## **Important Safety Recall Information**

### **Safety Recall Campaign# 21V-045**

<h1>SERVICE CIRCULAR</h1>	Issue no.	RE-IB-SC-11-R1
		Issue date	
		Page No	01 of 02
SUBJECT	FRONT AND REAR CALIPER ASSEMBLY REPLACEMENT RECALL		
APPLICABLE MODELS	INT 650, GT 650

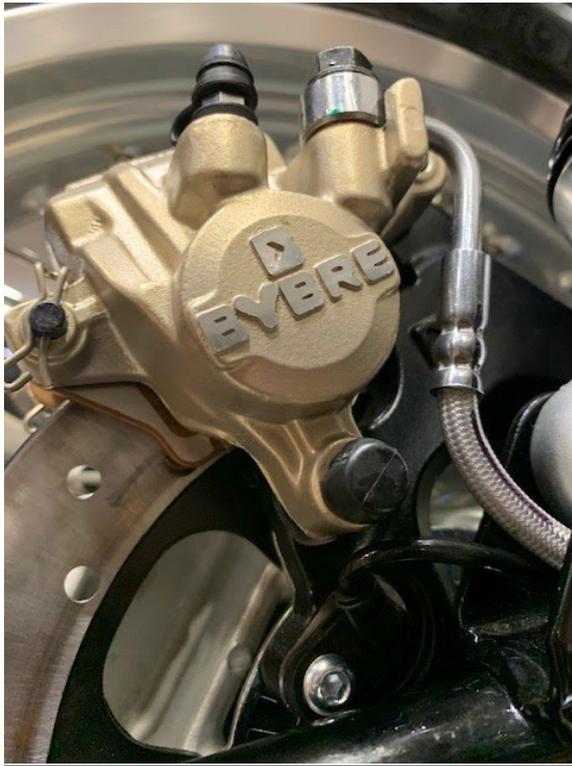
We are including photos as a visual indicator to confirm the completion of this action. The images below show the visual identification differences between the NON-Anodized and Anodized calipers.

The current non-anodized brake calipers (front and rear) will be replaced with anodized calipers (front and rear) The respective service manual outlines the proper procedure for caliper replacement. For convenience these have been attached.
